STATE OF WASHINGTON  
**DEPARTMENT OF ECOLOGY**

**Re: Comments on Sundberg Gravel Pit Remedial Investigation Work Plan**

- **Site Name:** Sundberg Gravel Pit
- **Site Address:** 2200 Cooper Pt Rd, Olympia, Thurston County, WA 98502
- **Facility/Site ID:** 82016954
- **Cleanup Site ID:** 10635

Thank you for submitting the draft Sundberg Gravel Pit Data Gap Report and Remedial Investigation Work Plan (Work Plan) received April 26, 2022. Ecology understands the Work Plan is a proposed attachment to the future agreed order between Ecology and Green Cove Park LLC. Ecology has reviewed the document and has the following comments:

Figure 1. Map from Stemen 1993<sup>2</sup> Report

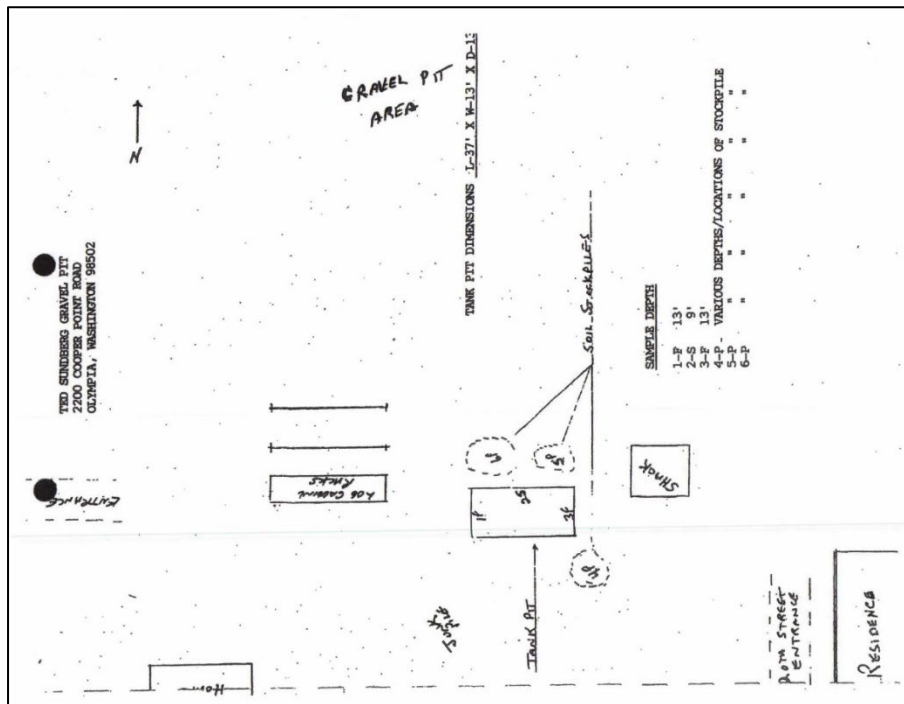
7. The location of the former diesel UST, in place from 1967 to 1993, appears incorrect. The Stemen 1993<sup>2</sup> tank removal drawing (Figure 1) shows the tank **northeast** of the home near a "shack" and between the home and "20th street entrance." The Stemen 1993 text also describes the UST's location as approximately 750 feet from the well located near the onsite residence. This distance is consistent with an UST near the shack that remains on the site and the structures in the south central part of the site shown on aerial maps from 1968 through 1996 (Figure 2 shows a 1990 aerial photo). It is not clear why the Work Plan Figure 7 shows the tank within 100-200 feet **northwest** of the former home.

**17. UST location and removal date:** Consider and correct the location of the former diesel fuel UST decommissioned and removed in 1993, not 2003.

Figure 2. 1990 aerial photo

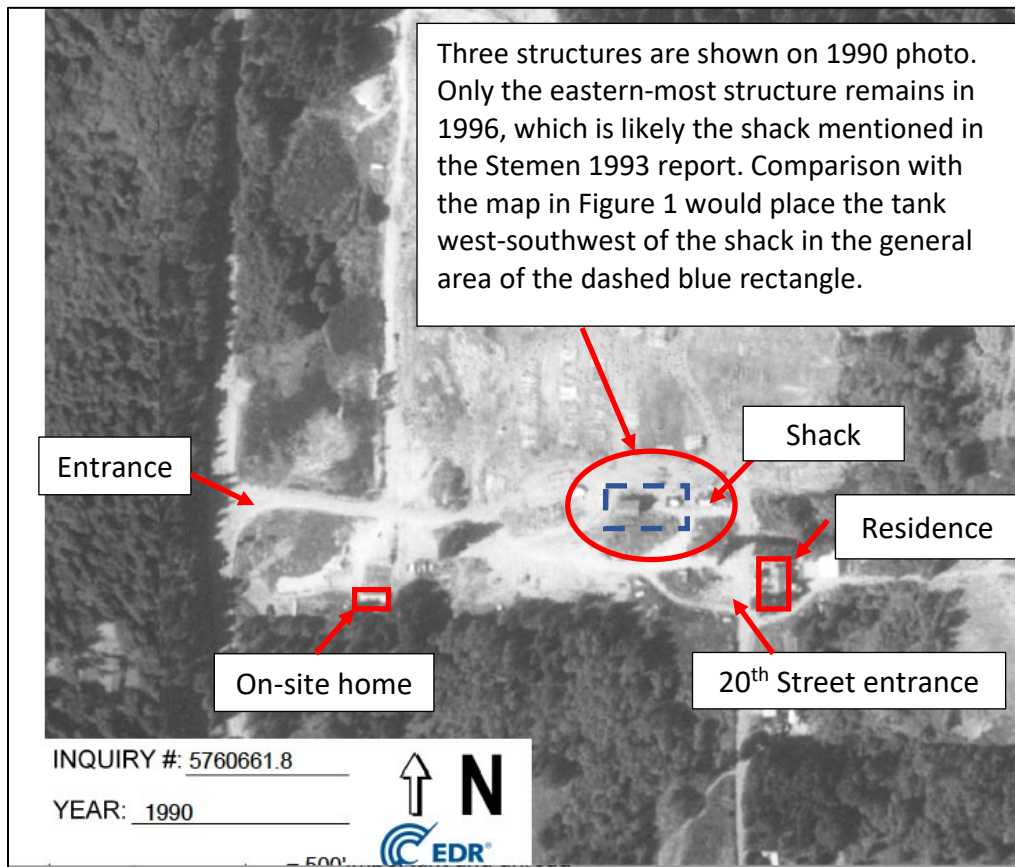
2. **Historic buildings or structures:** The history does not mention the three buildings seen in aerial photos (1968, 1973, 1980, and 1990) in the south-central part of the site near the current shack. From the aerial photos, this area appears to have served as the gravel pit's maintenance and garage area prior to the addition of the home and garage in the southwest portion of the site in the late 1980's or early 1990's. Amend the history to include information on this area.

**15. Former buildings/garage area:** Add as a suspected source the buildings in the south-central part of the site seen in aerial photos from 1968, 1973, and 1980. This area may have served as the garage or maintenance area prior to building the home and garage in the southwest part of the site in the late 1980's.
